## ARCHITECTURAL REVIEW BOARD MEETING

Thursday, October 27, 2022 at 7:00 PM

**ARCHITECTURAL REVIEW BOARD OF THE TOWN OF WARRENTON  
TOWN HALL  
21 MAIN STREET  
WARRENTON, VIRGINIA 20186**

Staff Report COA 2022-152 (22-28)

# Proposed Design: Front Porch

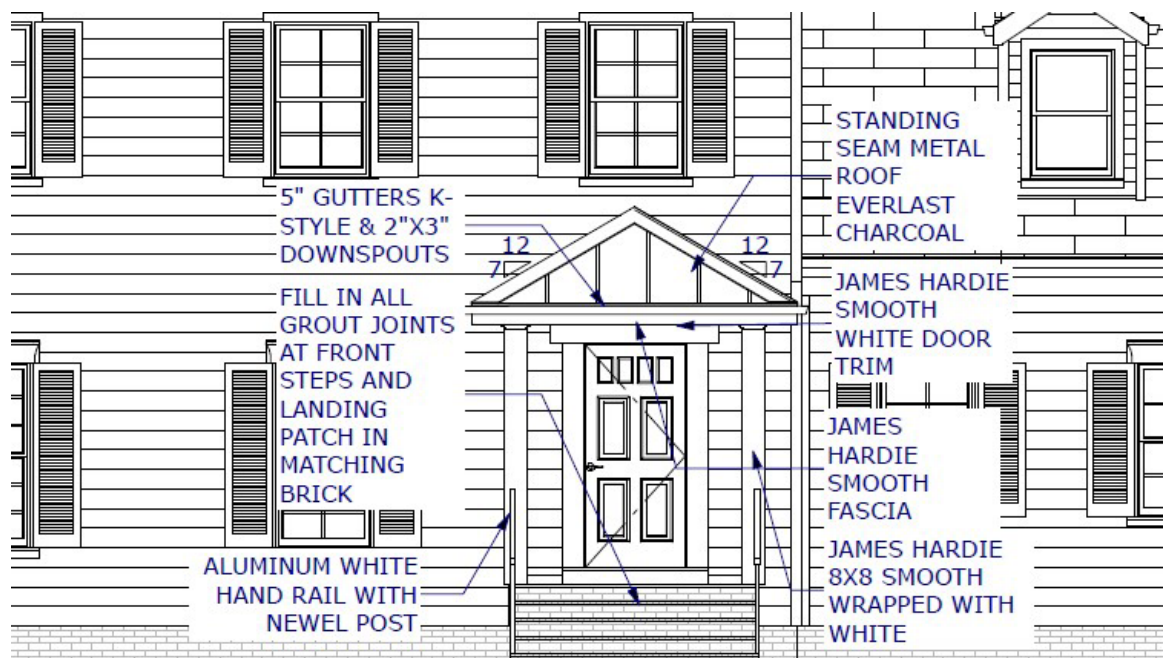
5.Design the replacement entrance, porch, or stoop to relate to the overall scale of the primary building. Research the history of the building to determine the location, appearance, and materials of the original entrance, porch, or stoop.	3.29	The proposed handrail is white aluminum to replace the existing wood handrail. The brick stoop is to be repointed and restored.

## Proposed Design: Rear Porch

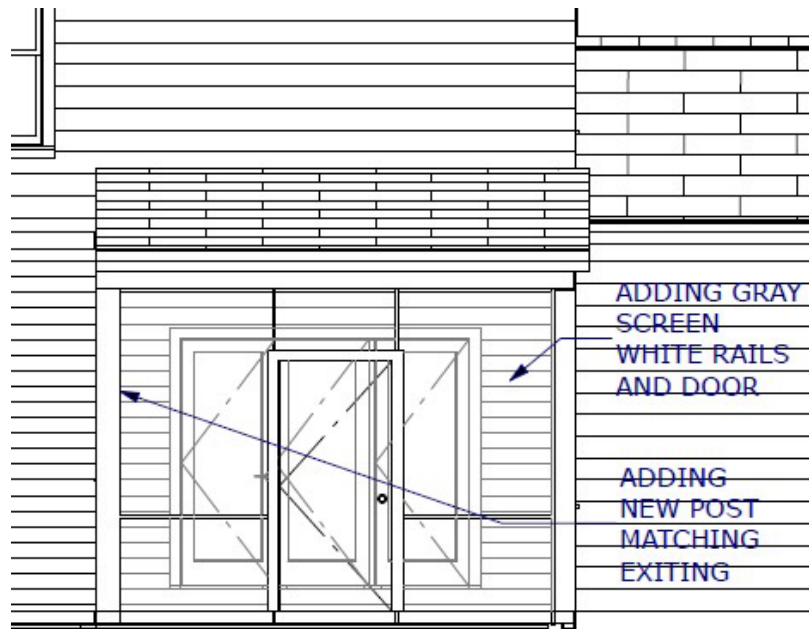
3. Replace in kind an entire window or door that is too deteriorated to repair. If the overall form and detailing are still evident, use physical evidence to guide the new work. Recreate doors and windows to match the appearance of the original window or door design. While modern window materials such as extruded composites will be considered on a case-by-case basis, the new window must match the original in terms of size, shape, profile, depth of sash, width, and setback. Wood doors on primary façades should be replaced with replica wood doors and only if the original is damaged beyond repair. These guidelines encourage the use of substantial and durable materials.		A new screen door for the screened in porch at the rear of the property is being proposed.
